City of Detroit
City Engineering Division, Department of Public Works
Survey Bureau

NOTICE OF PROPOSED CHANGE IN PROPERTY

Petition: x867 R.A

PETITION x867 R.A.

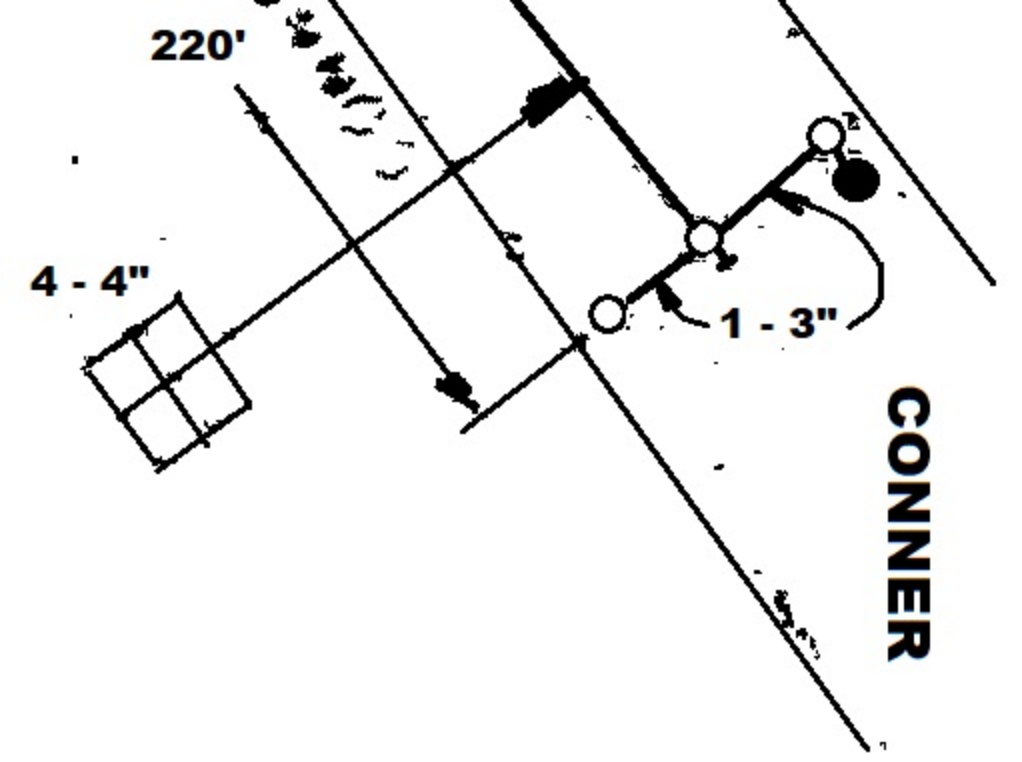
BRACKET & LIGHT
TO BE REMOVED

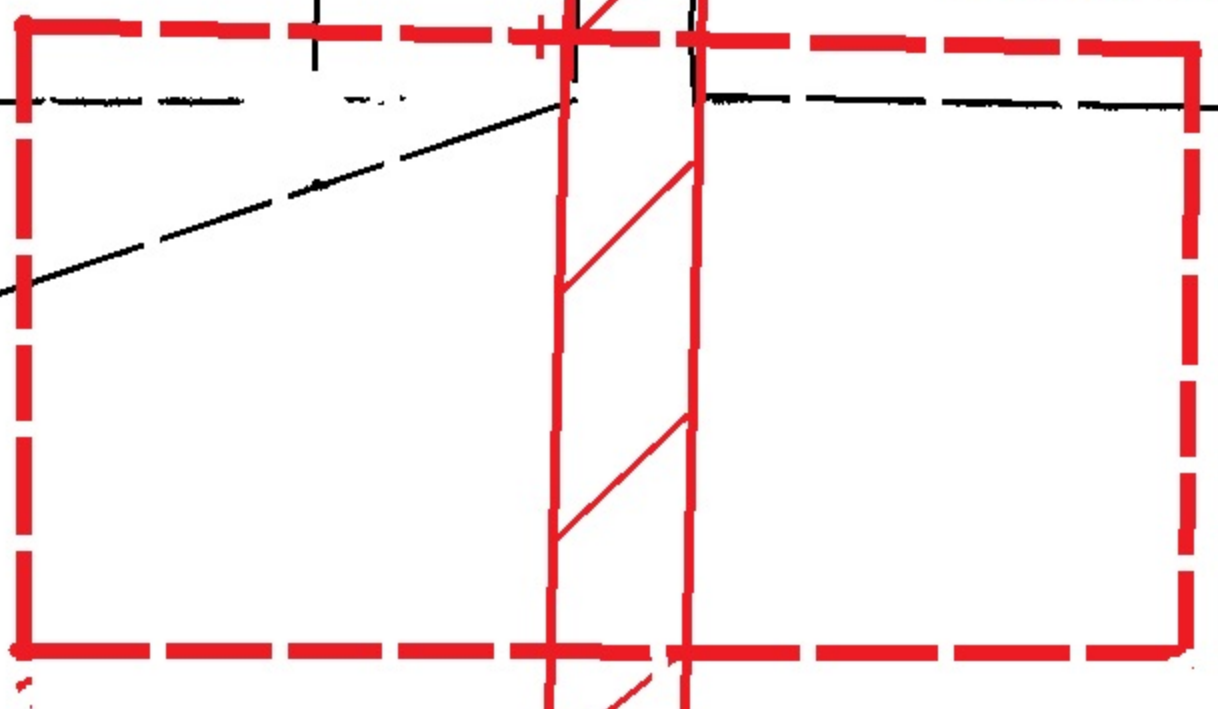
NOTE: OBJECTION TO THIS AREA OF REQUESTED OUTRIGHT VACATION.
HIGH TENSION 24KV CABLE CAN NOT BE REMOVED AT THIS TIME.

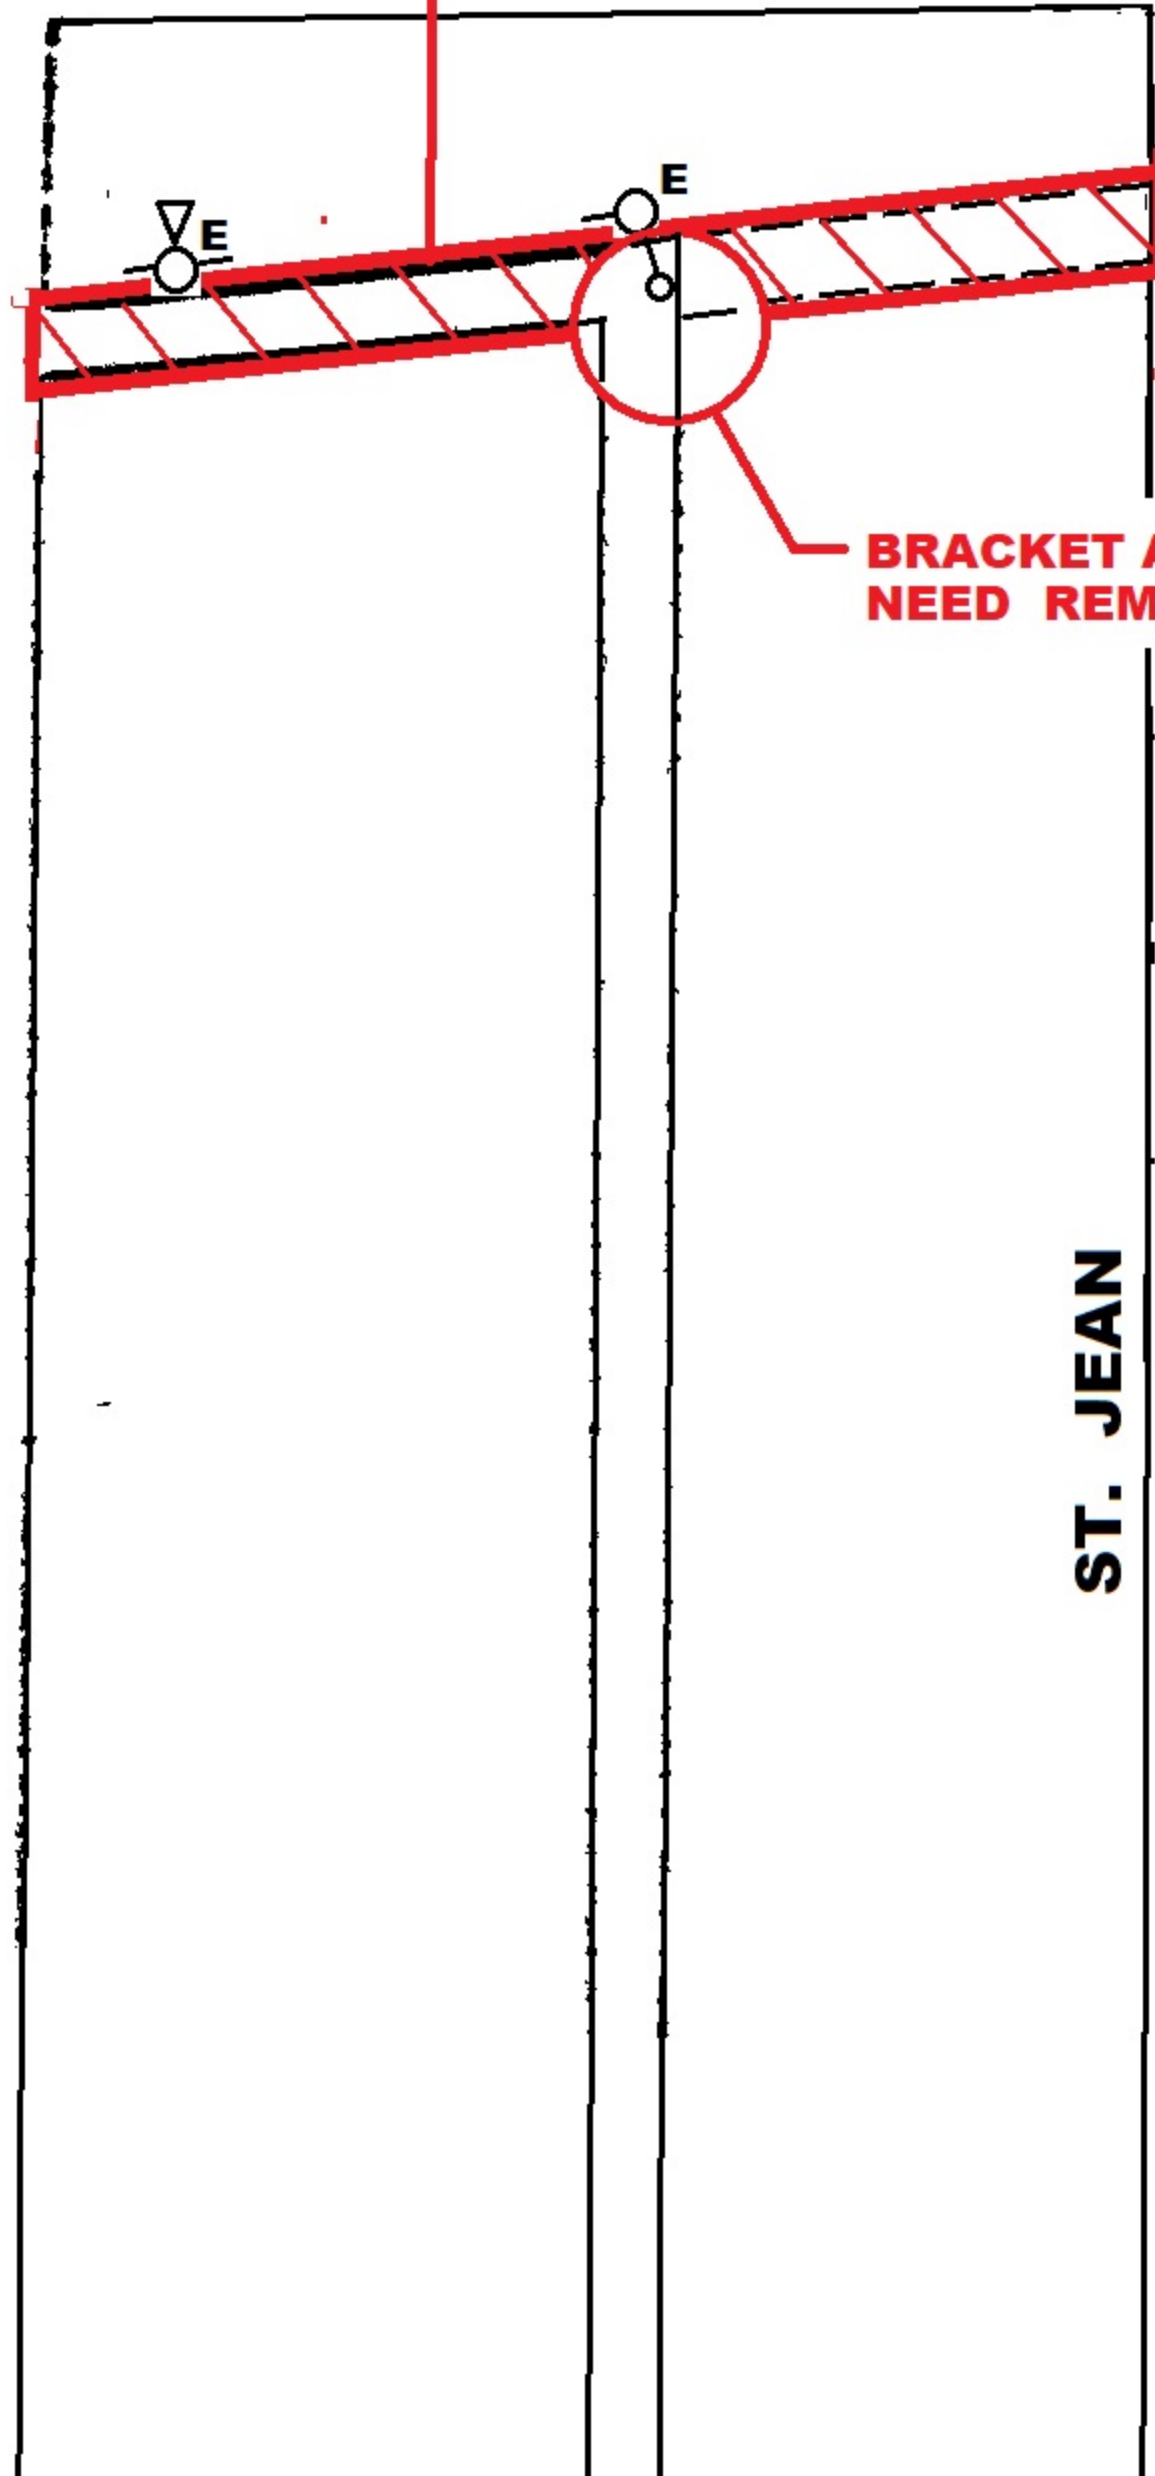
BRACKET AND LIGHT
NEED REMOVAL

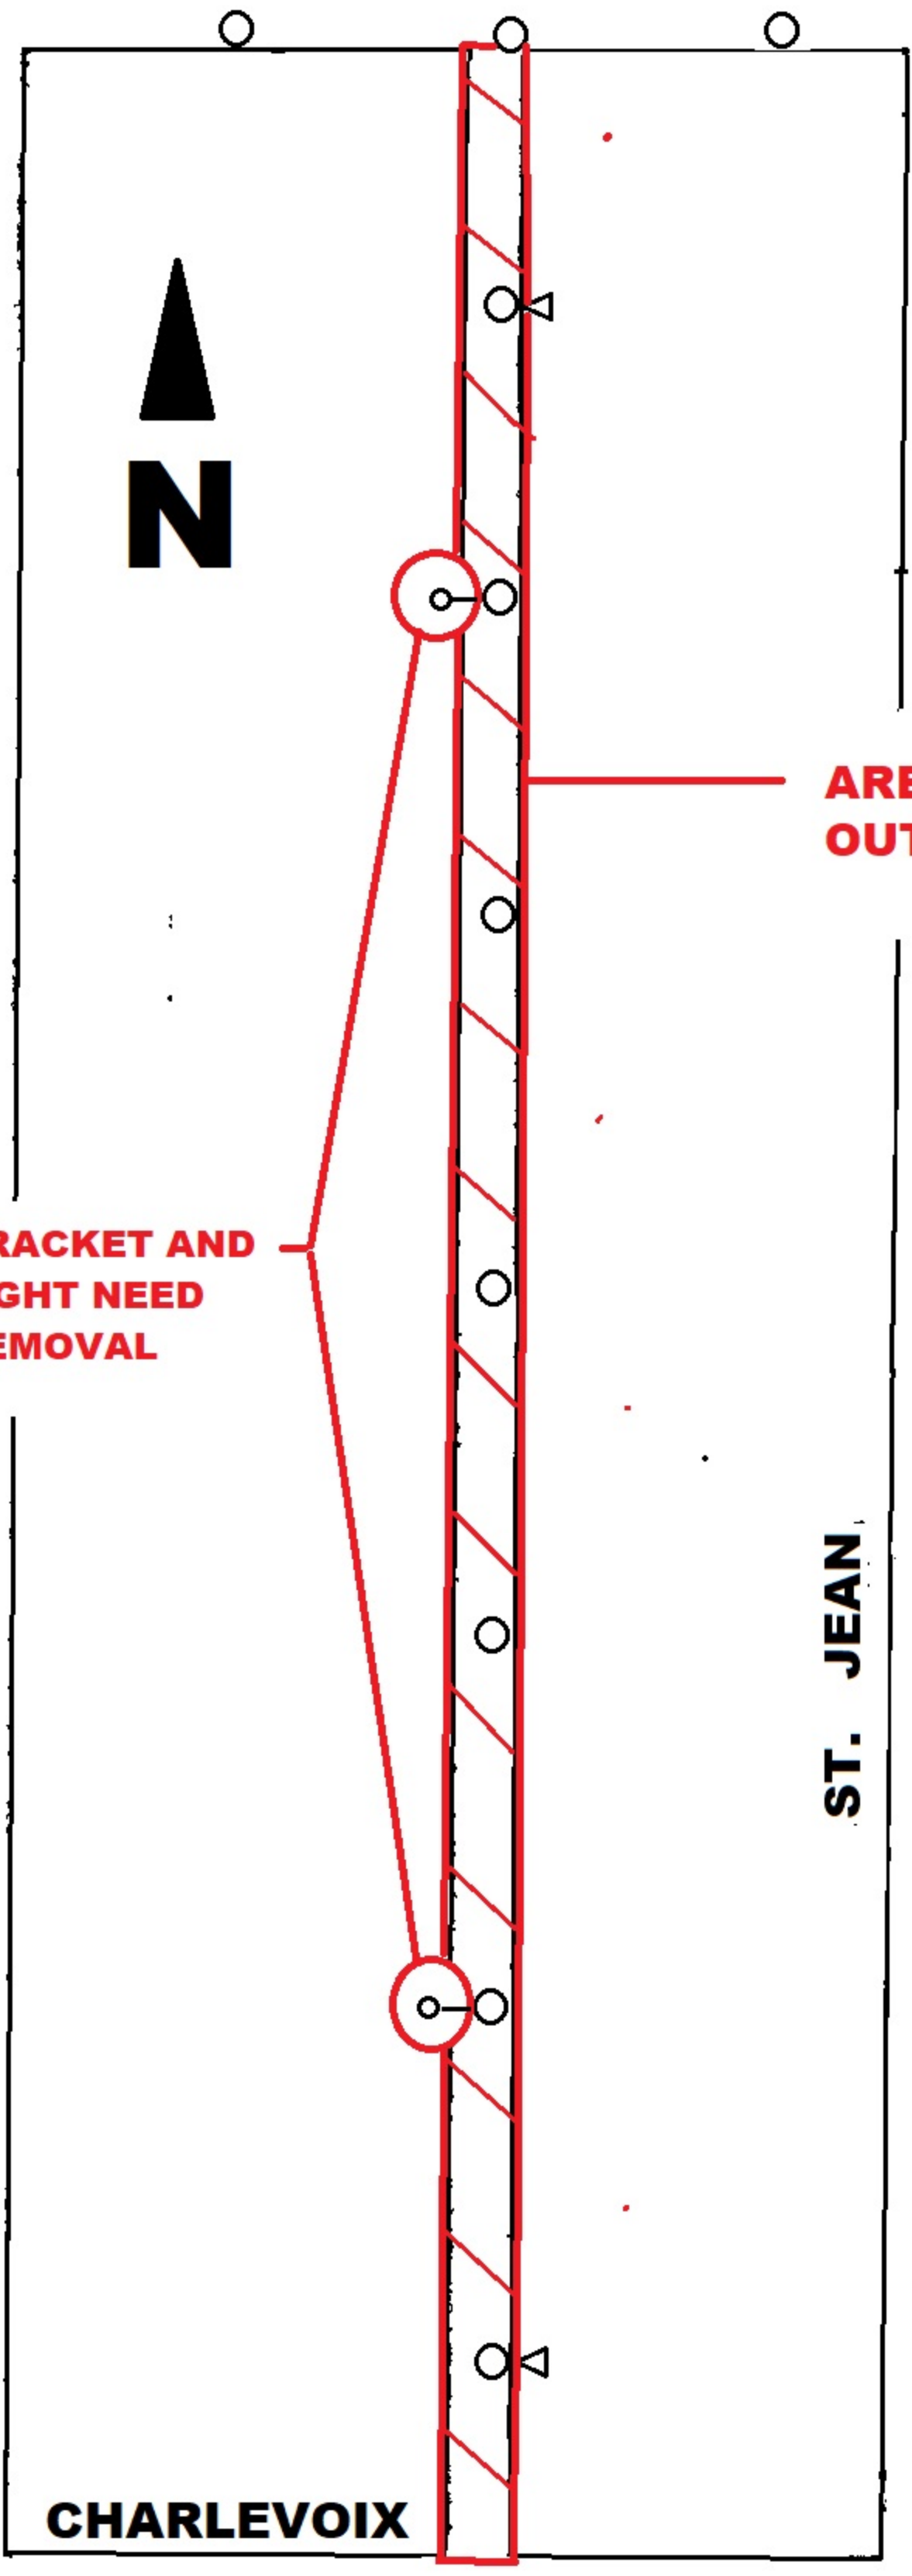
**BRACKET AND
LIGHT NEED
REMOVAL**

BRACKET & LIGHT
NEED REMOVAL

CABLE POLE
NO LONGER EXISTING

WIRES SPLICED IN
P.L.D. HANDHOLE

PETITION x867 R.A.

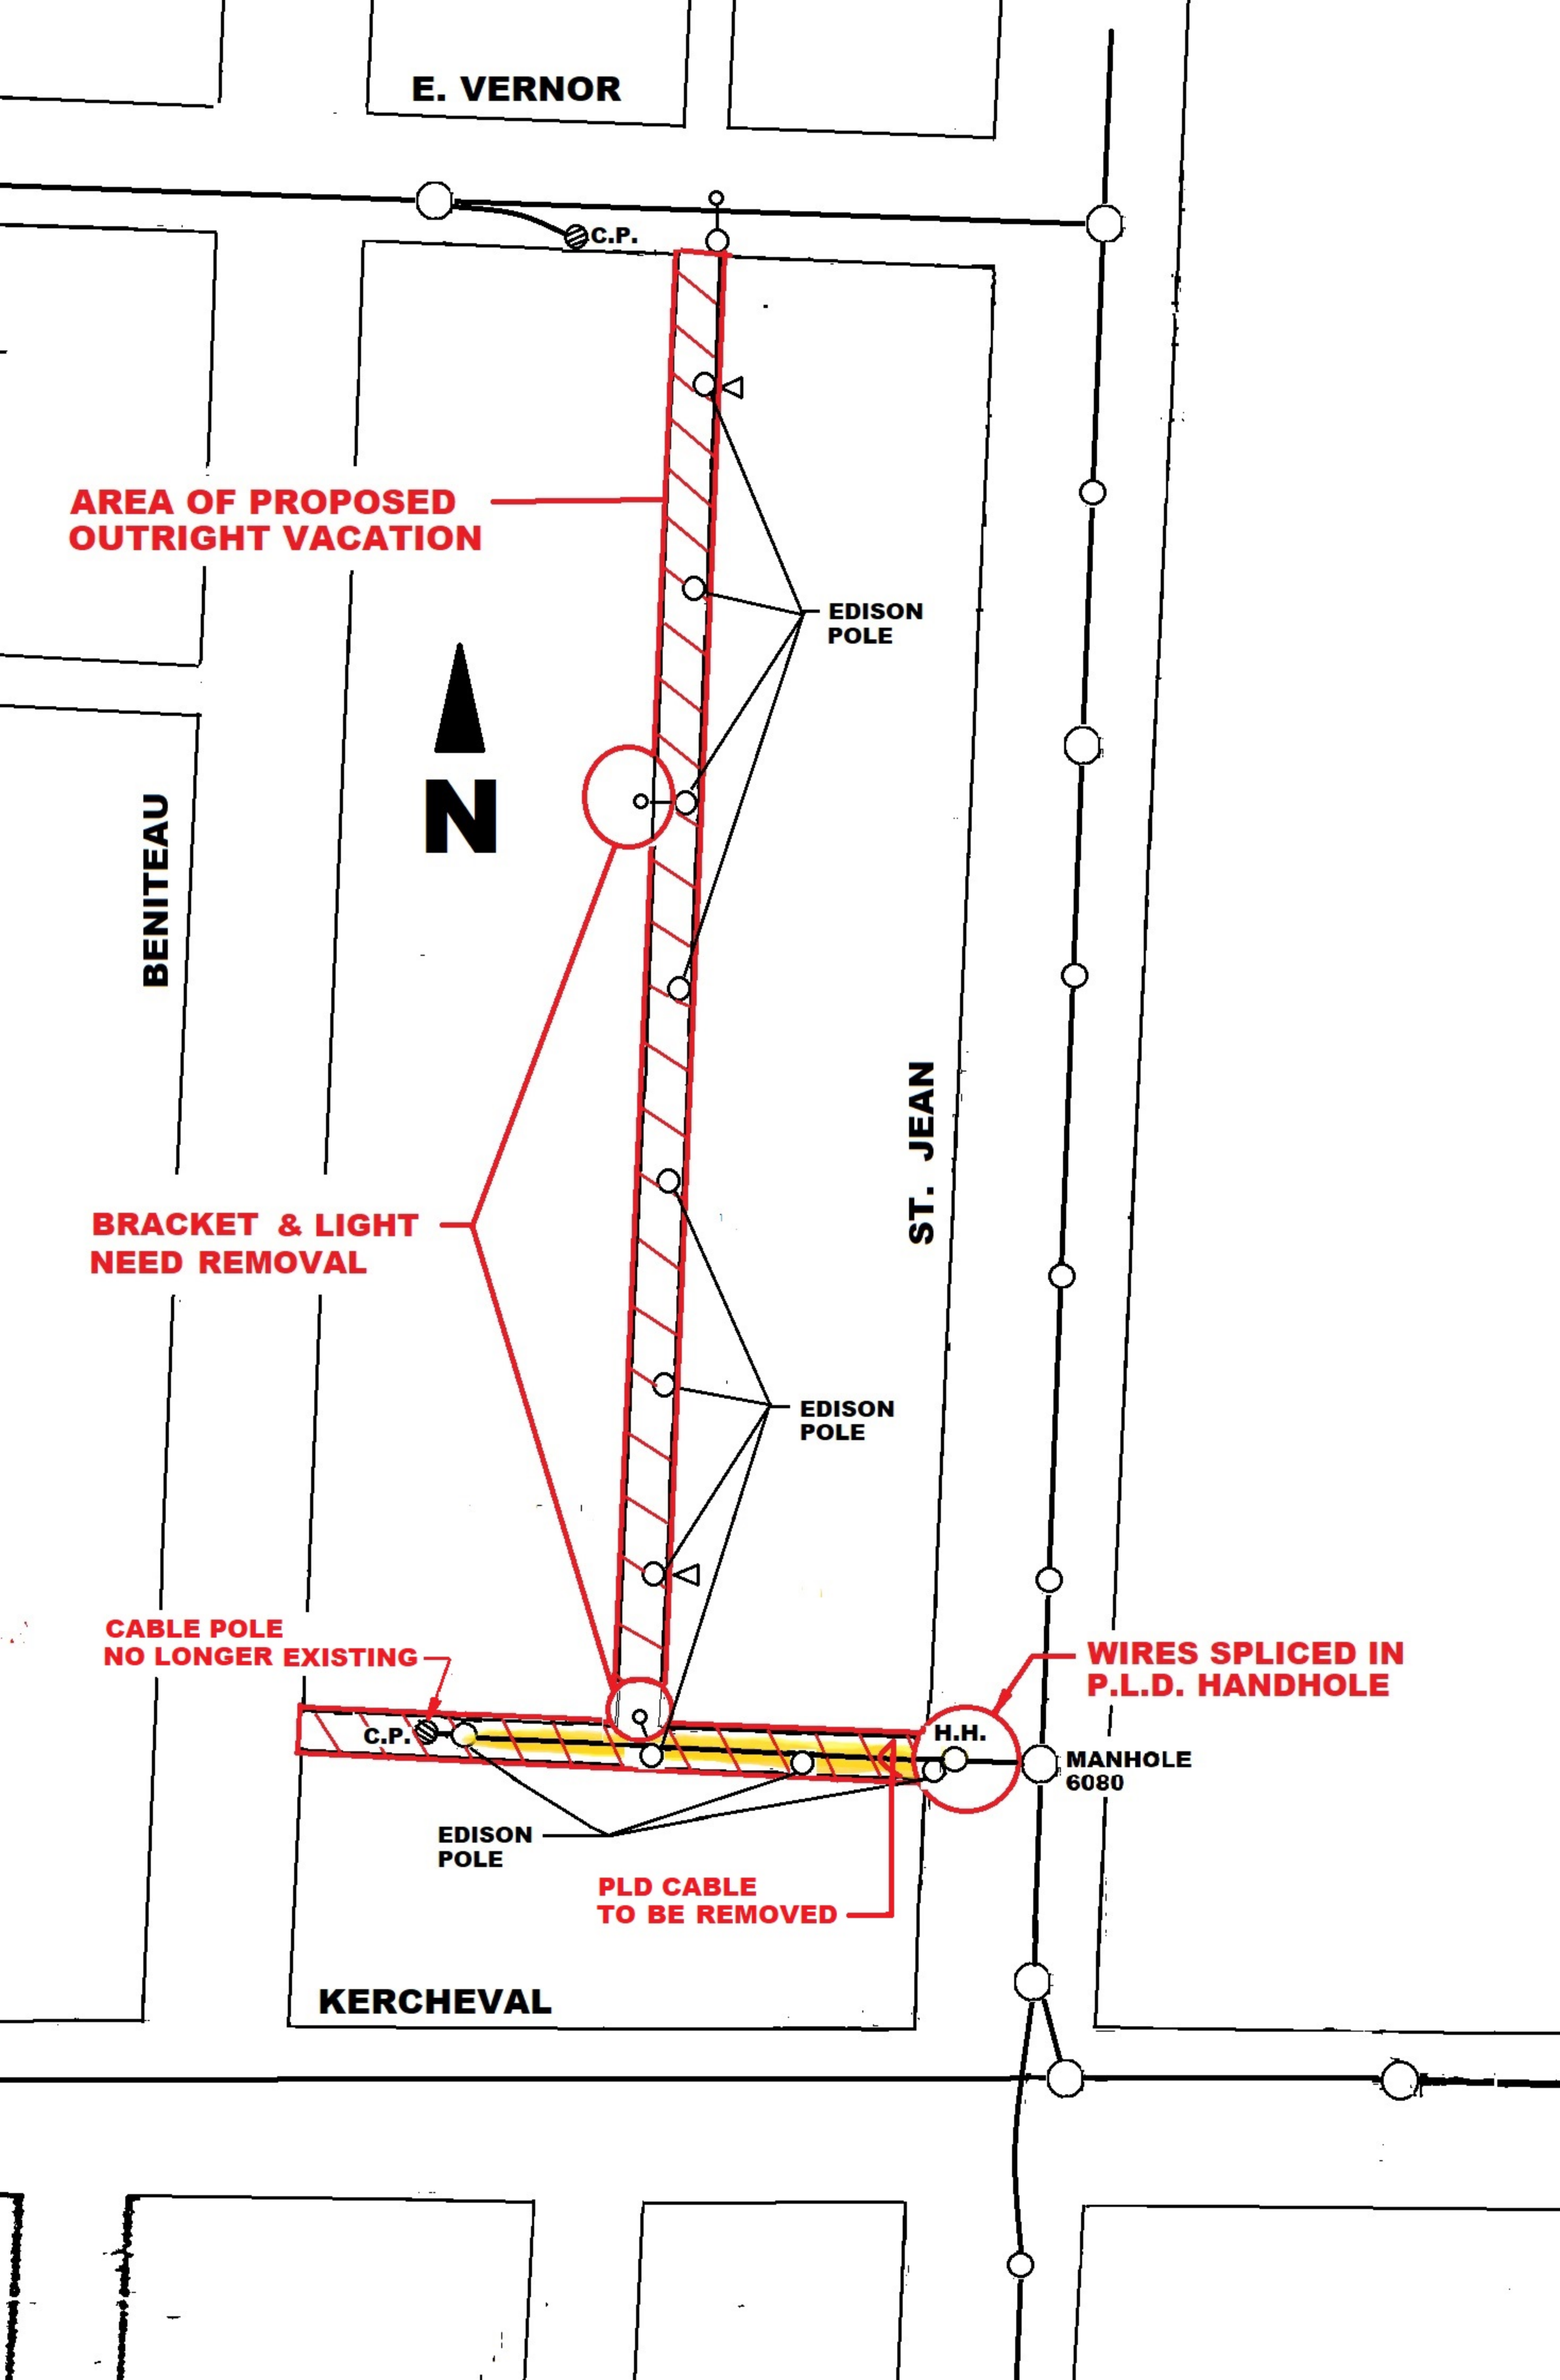
PLD CABLE
TO BE REMOVED
